DEPARTMENT OF DEVELOPMENT SERVICES – PLANNING DIVISION

REPORT: Lot combination of 888 Tower Avenue and 890 Tower Avenue, for consideration on Tuesday November 22, 2022

# STAFF REPORT

Figure 2. Proposed lot combination submitted by applicant, last revised November 9, 2022.

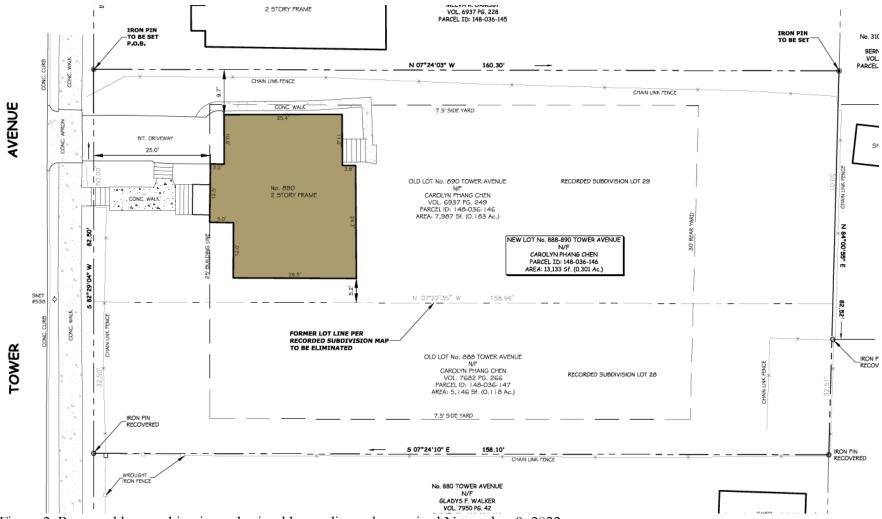
- Request to combine 888 & 890 Tower Avenue into a single rectangular lot that would measure 0.30 acres with a front lot width of 82.5 feet, as shown in Figure 2.

- The lot combination would render the primary structure's front lot line coverage nonconforming. House Type C buildings have a minimum front lot line coverage requirement of 65%. The existing structure at 890 Tower Ave currently has a conforming lot line coverage of 70%. However, with the lot combination, it would decrease to 52%. This difference is greater than 15%.

- The lot combination would eliminate the nonconforming lot width of 888 Tower Ave. The vacant parcel at 888 Tower Ave currently has a lot width of 32.5 ft, whereas the minimum lot width required for House Type C building types is 40 ft. The House Type C is the only building type permitted in the N-4-1 district and this difference is greater than 15%. Furthermore, such a narrow lot may be difficult to develop regardless of its nonconformity. While Section 1.5.2.B of the Zoning Regulations states that uses are permitted on lots with nonconforming lot widths or lot areas, this element remains a relatively major nonconforming characteristics that would be eliminated.

- The lot combination would eliminate the nonconforming side setback of the primary structure. The existing structure at 890 Tower Avenue has a 5.2 ft side setback to the east property line. A minimum of 7.5 ft is required for House Type C. The proposed lot combination would eliminate this nonconformity.

Staff recommends approval of the proposed lot combination, with the following conditions:

- 1. All outstanding taxes associated with the subject properties shall be paid prior to final approval of the requested lot combination.
- 2. The applicant shall submit a mylar of the proposed lot combination and pay the required recordation fee for this application type.
